SERVICE BULLETIN

No. SB-NG-1-21

Subject:	Starter Solenoid Circuit
Aircraft affected:	EXTRA NG: S/N NG019, NG021 through NG025 and those retrofitted with ACS A-510-2 Ignition Switch.
Purpose:	<p>The ACS A-510-2 Ignition Switch was introduced as an alternative part into the EXTRA NG Type Certificate. To protect this ignition switch from induced voltage at the moment the starter solenoid opens, a flyback diode was placed across the starter solenoid coil terminals. This required flyback diode noticeably delays the release of the solenoid by keeping the coil current flowing longer. An arc across the opening internal contacts of the solenoid may occur, preventing a release to open position. This will cause a prolonged starter engagement going along with high alternator current draw and final starter overheating.</p> <p>Adding a Zener diode in series with the already present flyback diode, but in the opposite direction, will make the circulating current decay faster at the drawback of an increased reverse voltage.</p>

Figure 1: Starter Solenoid on Electrical Main Board

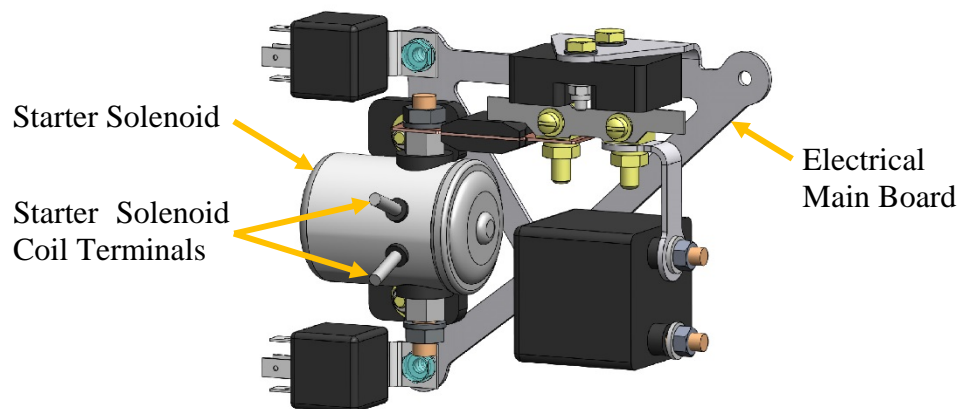
1. Make sure the aircraft is powered down.
2. Remove the bottom fuselage access panel as per Chapter 51-00-01 and 53-30 of the EXTRA NG MM and disconnect the main battery.
3. The starter solenoid is installed on the electrical main board, see Figure 1 and 2. The electrical main board is installed behind the LH landing gear cuff, see Chapter 51-00-01 of the EXTRA NG MM.

Figure 2: Electrical Main Board behind LH Landing Gear Cuff

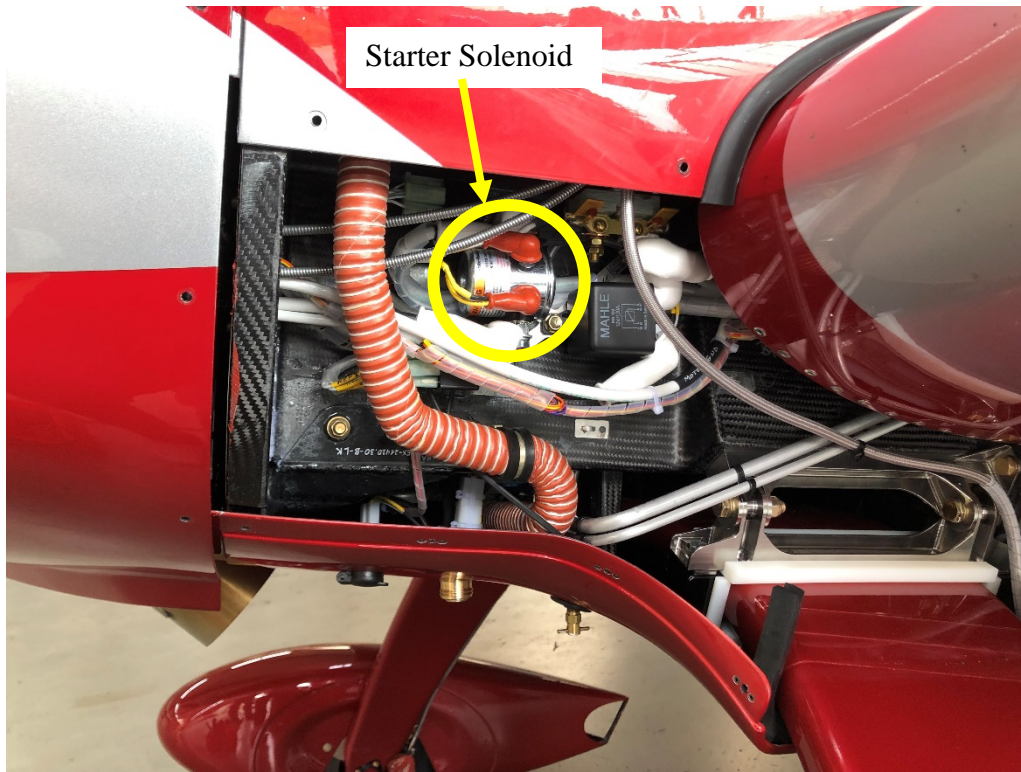
4. Remove top and bottom halves of the engine cowling as per Chapter 71-10 of the EXTRA NG MM.
5. Remove the LH landing gear cuff as per Chapter 53-30 of the EXTRA NG MM.
6. Note that the coil of the solenoid does not have a positive and a negative terminal. The coil causes a magnetic field that attracts the relay plunger regardless of the direction of the magnetic field. The positive terminal is connected to the Slickstart module and ignition switch. Both coil terminals are protected with a cover nipple.
7. Identify the starter solenoid positive coil terminal and remove the cover nipple, the nut and the washer. Use a back-up wrench to hold the bottom nut stationary when releasing the outer nuts.
8. Remove the ring terminal from the black wire with the red heat shrink tubing band (wire between coil terminals with flyback diode).

Figure 3: Starter Solenoid Wiring with opposite oriented Diodes

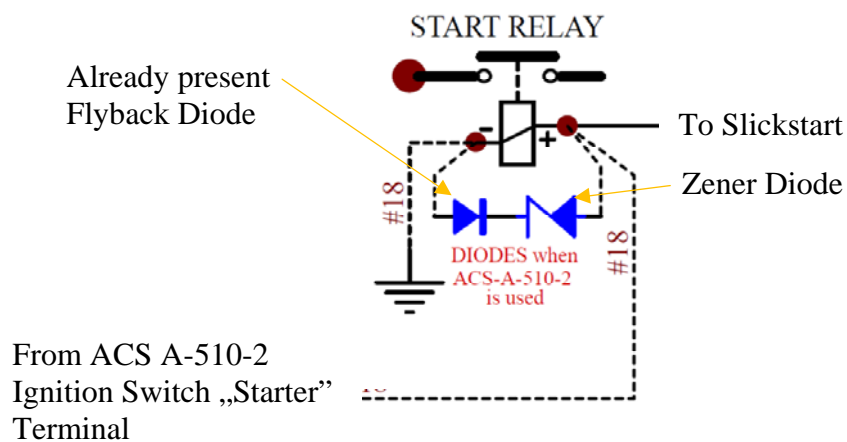
9. Cut the wire between the flyback diode and the loose ring terminal and dispose of the ring terminal.
10. Remove the insulation on the remaining wire.
11. Attach the Zener diode (EXTRA P/N 35842) in opposite direction of the present flyback diode using a crimp contact (EXTRA P/N FE4108), see Figure 3.

12. Put on heat shrink tubing long enough to cover the complete area.
13. Attach a 20 AWG aircraft wire (MIL-W-22759, EXTRA P/N 00775) with a ring terminal (EXTRA P/N 02198) to the other end of the Zener diode using a crimp contact (EXTRA P/N FE4108).
14. Pull back the heat shrink tubing to cover all parts and connections and use a heat gun to shrink it in place.
15. Install the ring terminal on the positive coil contact and attach with previously removed nut and washer (Max torque 45-55 inch-lbs / 5–6.2 Nm). Use a back-up wrench to hold the bottom nut stationary when applying the outer nuts.
16. Reinstall the cover nipple on the starter solenoid positive coil terminal.
17. Reconnect the battery.
18. Test the starter solenoid circuit for proper operation.
